REGULAR MEETING AGENDA

Tuesday, March 24, 2026

**CHARTER TOWNSHIP OF YPSILANTI
PLANNING COMMISSION MEETING
Tuesday, December 9, 2025
6:30 pm**

Re: Preliminary Sketch Plan: 2575 State St. (Pegasus Concrete Plant/ Private Driveway)

Figure 3. Approved Landscaping along Wildwood Ave.

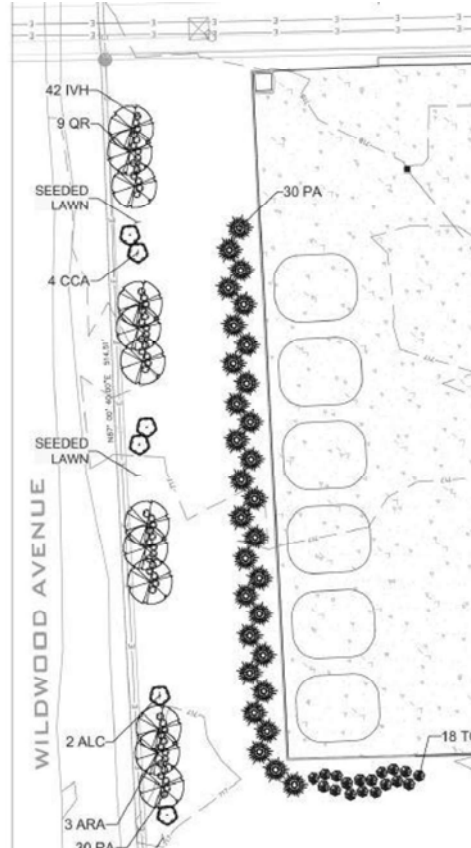
The landscaping on the approved site plan will need to be included in this project, as it has not been installed. The original landscaping within this area consists of 48 evergreen trees, 12 deciduous shade trees, 6 understory trees, and 42 shrubs. Also, where landscaping was installed on the site, it is clearly not being maintained or irrigated, and much of the plant material along Watson Ave. is in poor condition. Note that Sec. 1301(j) requires that where landscaping is required by the ordinance as part of an approved site plan, it shall be maintained in reasonably healthy condition.

PAVEMENT CROSS SECTION
 NOT TO SCALE

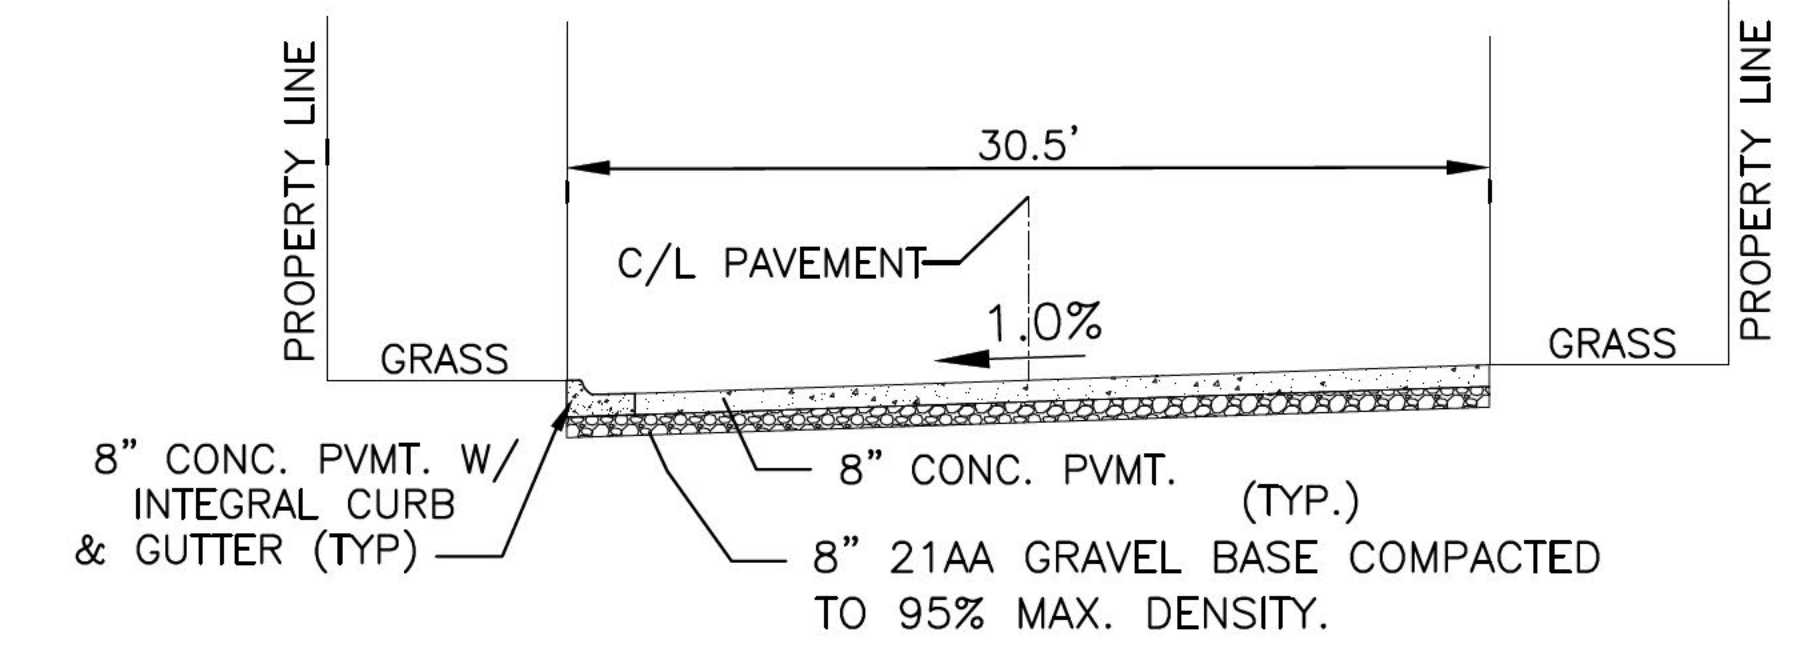
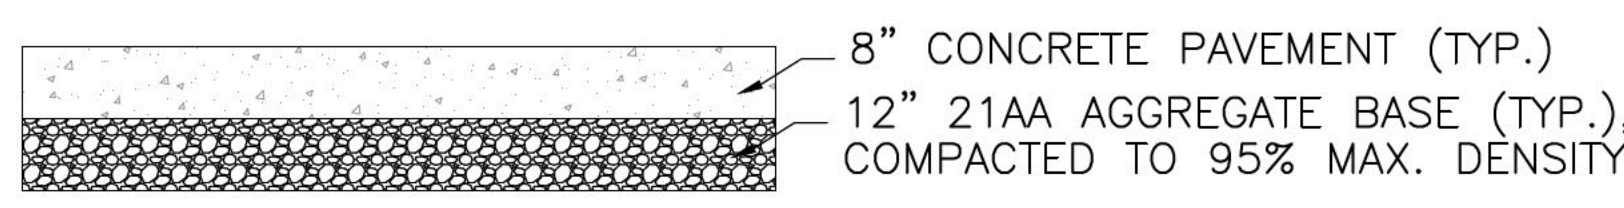
1. WCRC would require using a thickened concrete section or a tapered slab to help reduce edge stress at the asphalt and concrete interface and ensure enhanced performance and longevity of the pavement. This will also help to maintain a closed joint at the transverse joint, (see example detail below). *Please note that WCRC is not suggesting that a 2-foot-thick edge is necessary as depicted in the detail, just that it be thicker than the 8-inches proposed.*

2. WCRC would also require a minimum of 12 inches of 21AA aggregate base beneath the concrete pavement, instead of the 8-inches proposed.
3. A Road Improvement Agreement (RIA) shall be entered into with the WCRC. A draft version is circulating through WCRC and when finalized will be forwarded to applicant for review. I have included a draft version, attached to this email, please review and include applicant's comments/suggestions.
4. If the depth of stormwater catch basin 2, (designated as cb-02), is less than 4 to 5 below existing grade, WCRC would require complete removal, not abandonment in place.

SHEET NUMBER
CS-100

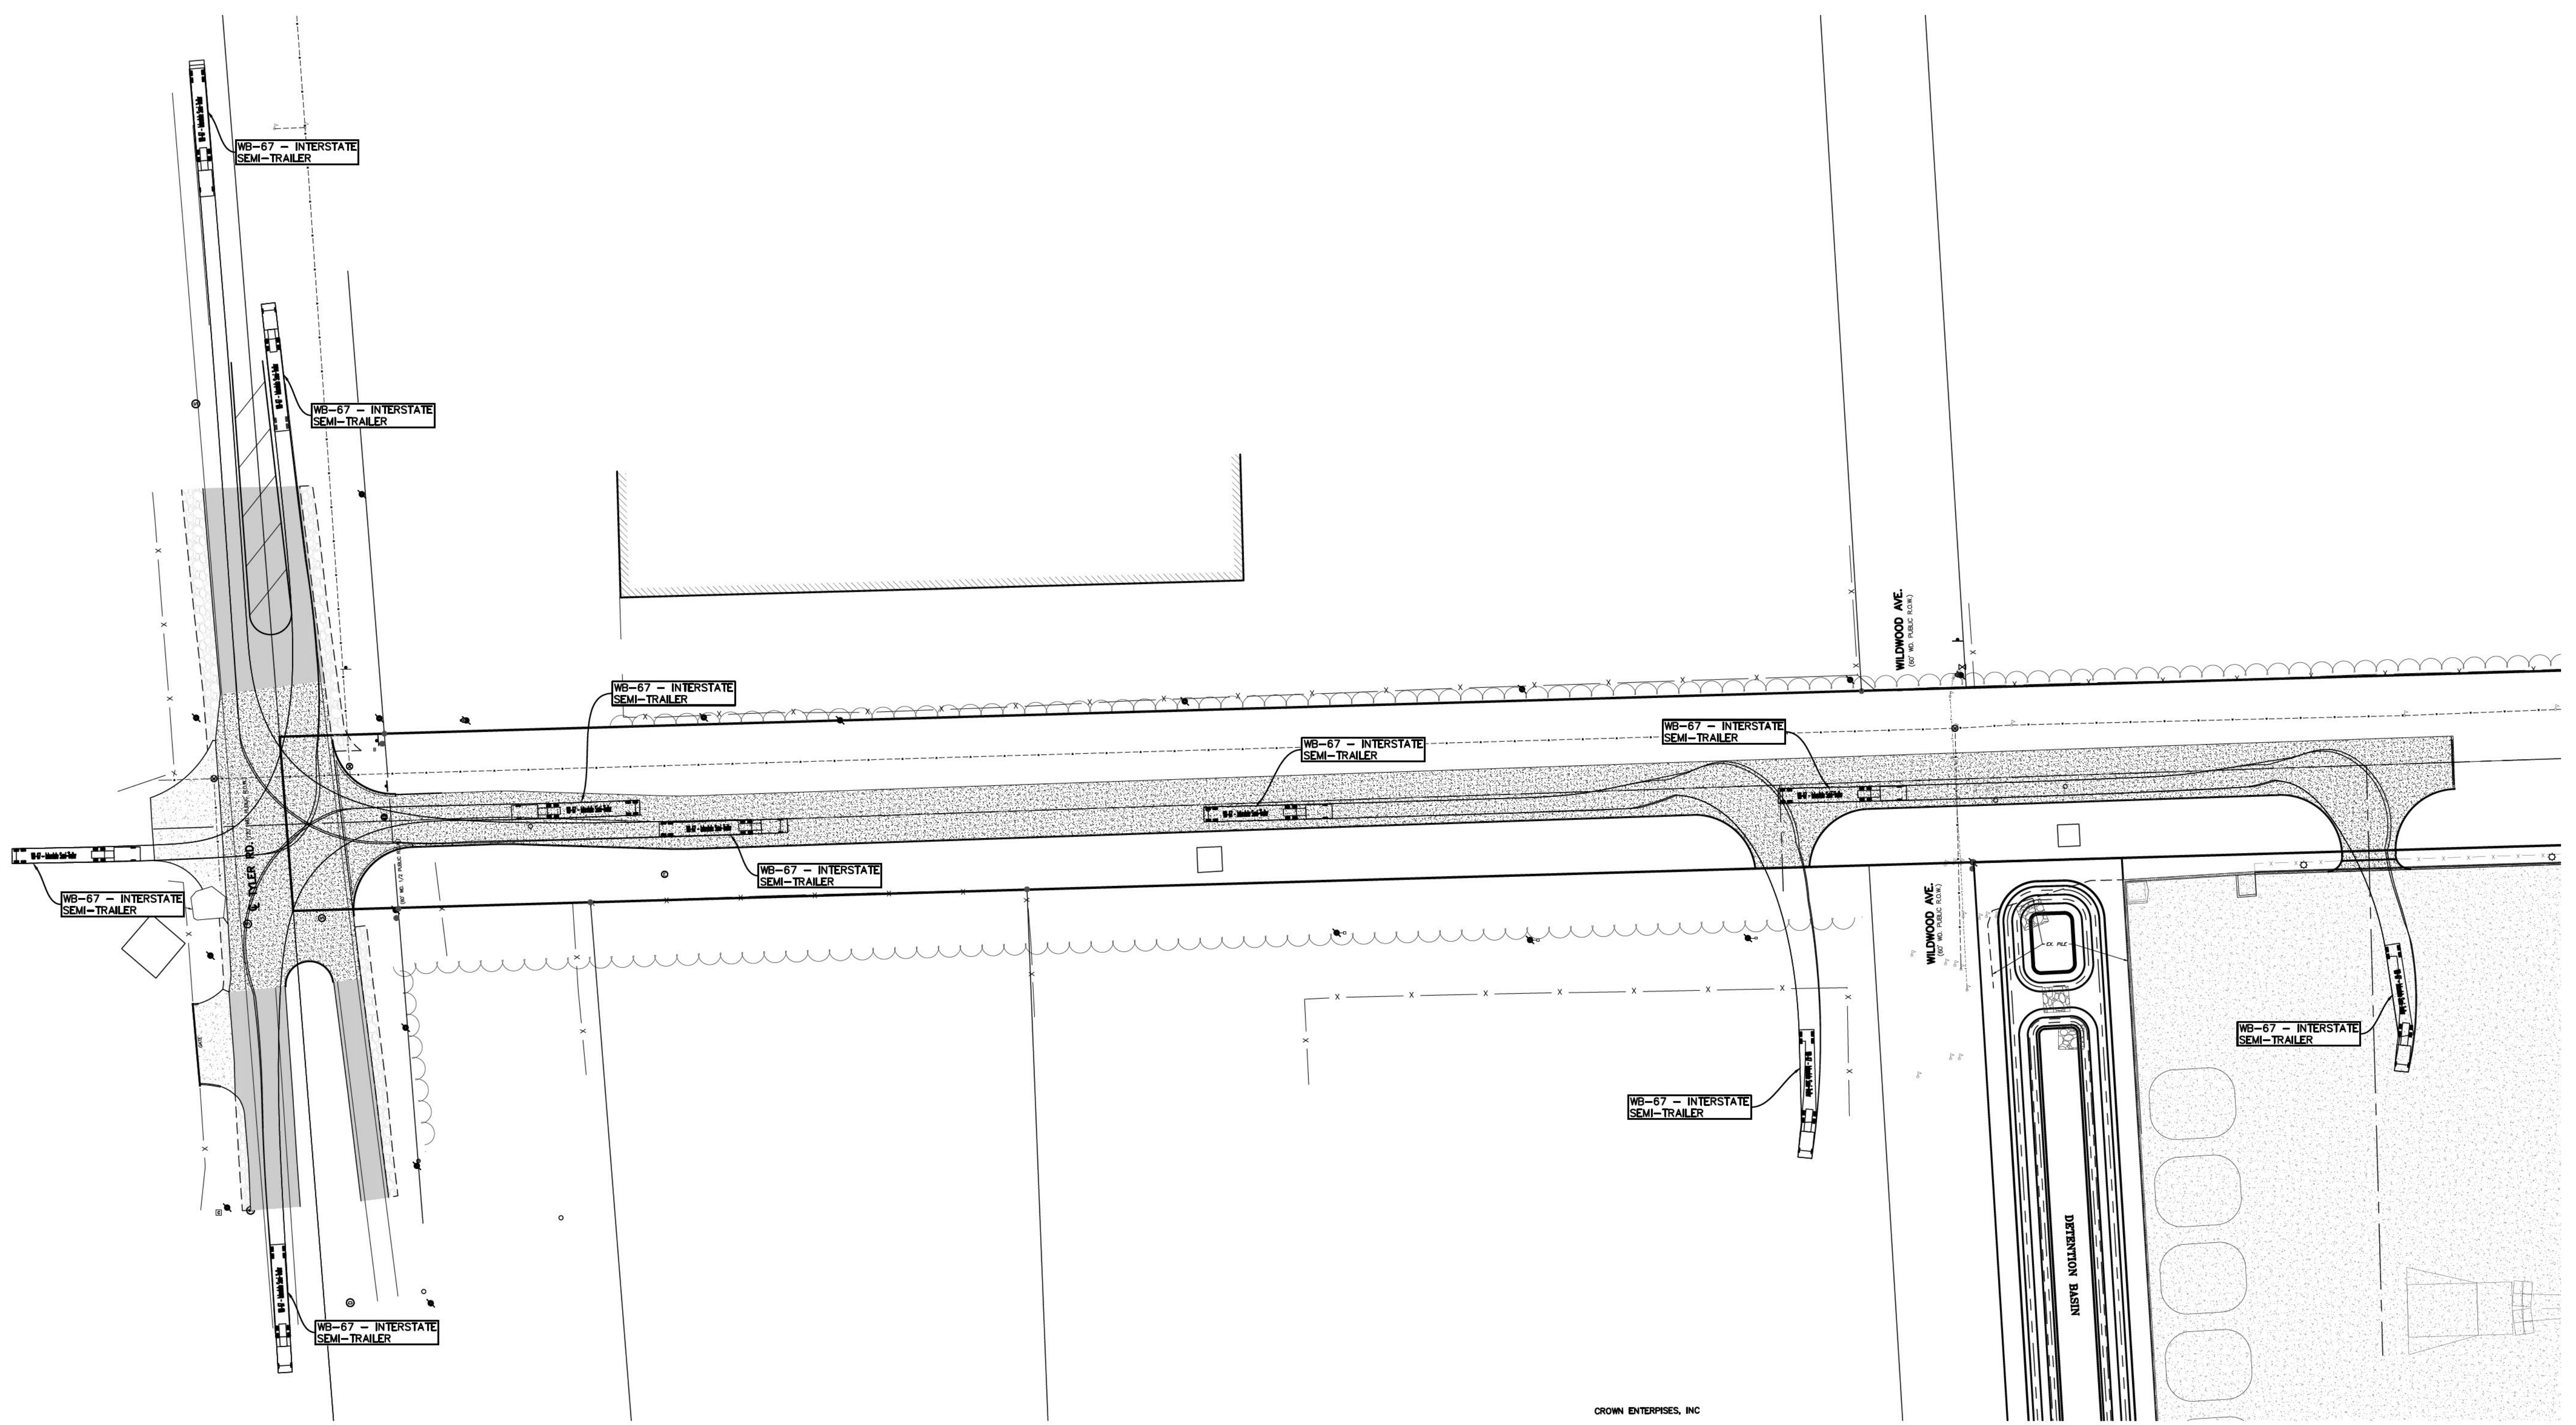
1. The applicant shall verify the scale on Sheets CS-101 and CG-100 as there appears to be a discrepancy.
